AGENDA REPORT

SUBJECT: To consider and approve a resolution to remove plat notes 16 and 17 from the

approved Cornerstone at Kelly Lane Phase 1 Final Plat.

Exhibit A: Cornerstone at Kelly Lane Phase 1 Final Plat

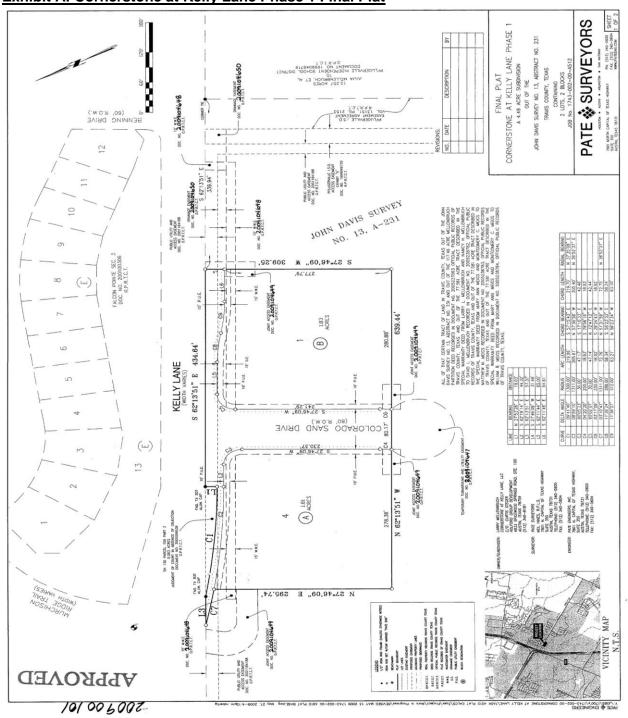
In 2009, the final plat for the Cornerstone at Kelly Lane Phase 1 was approved. Since approval of the play, Timewise gas station has developed at the corner of Kelly Lane and Colorado Sand, on Lot 4 of the subdivision. When Cornerstone at Kelly Lane Phase 1 was being reviewed initially, the future development plans for Colorado Sane Drive were not known. The City Engineer at the time required plat notes 16 and 17 which limited access to Lots 4 and 5 of Block A and Lots 1 and 2 of Block B as right in/right out (Exhibit "A").

In August 2012, CVS submitted a site plan to develop Lot 1 (SE corner at Kelly Lane/Colorado Sand) of the Kelly Lane Phase 1 Subdivision. CVS requested in the site plan, an opportunity for a left turn in to Lot 1 of the Subdivision. Prior to the formal CVS submittal, the City had begun design of the Colorado Sand roadway extension project. After discussions between the Planning Director, the City Engineer, and the design engineer for the CVS development, it was determined that a median opening could be accommodated on Colorado Sand for Lots 1,2,4, and 5 and would not negatively impact future Colorado Sand roadway project. As a result of the collaboration on Colorado Sand, plat notes 16 and 17 are no longer needed as now access can be provided. The CVS site plan shows the proposed left turn lane off of Colorado Sand Drive (Exhibit "B") that will not negatively affect traffic on Colorado Sand Drive. By removing these plat notes (#16 and #17), both Lots 1 and 4 will benefit from the changes proposed.

Plat Note 16 and Plat Note 17 no longer serve their intended purpose and City staff has approved removal of the notes (see attached approval letter from City Engineer). Staff recommends approval of the request to remove these notes from the Cornerstone at Kelly Lane Phase 1 Subdivision plat.
